February 17, 1995

WORKPLAN
for
SOIL AND GROUNDWATER
ASSESSMENT, NO. 2807
at
Eden Hospital Medical Center
20103 Lake Chabot Road
Castro Valley, California

TYPICAL
MONITORING WELL CONSTRUCTION
IN CROSS SECTION

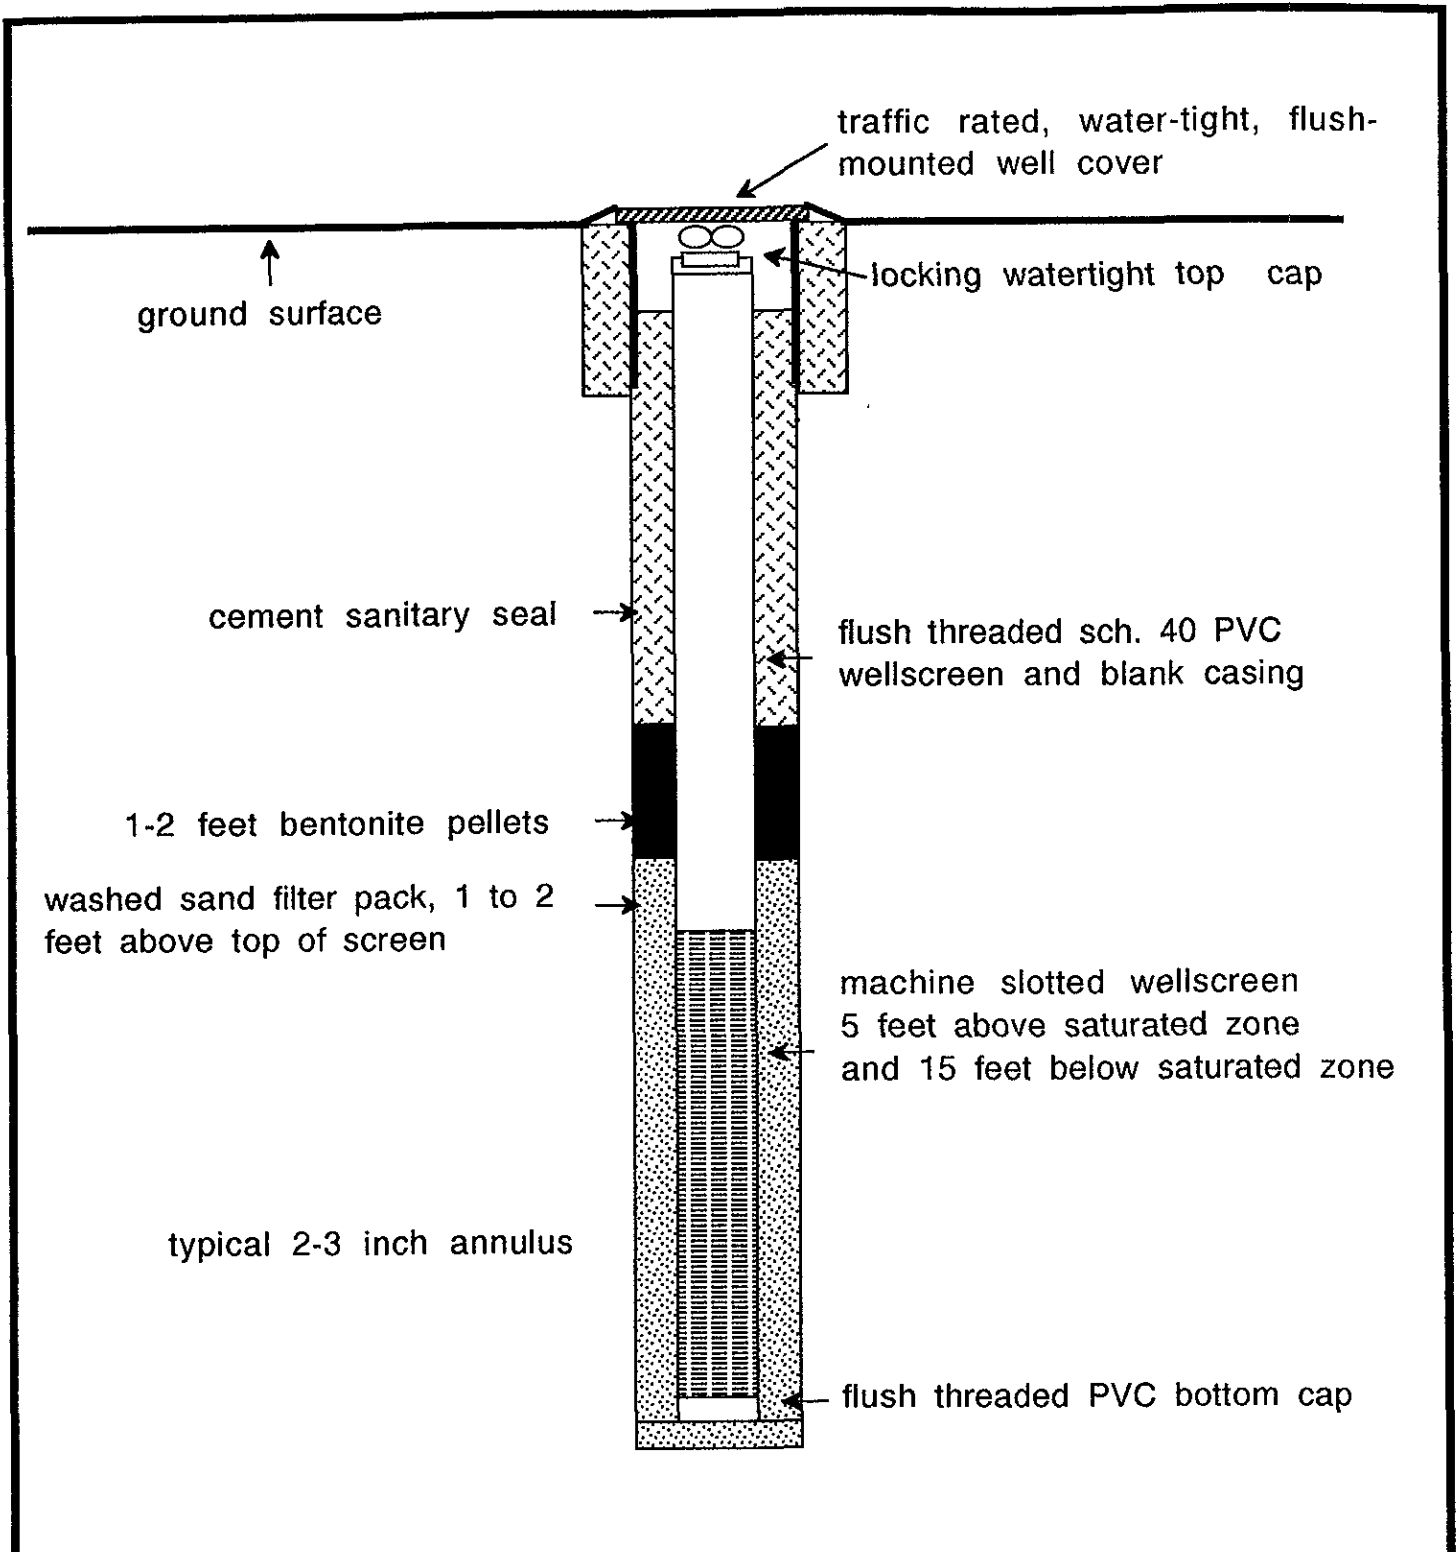
15'
Screen
max
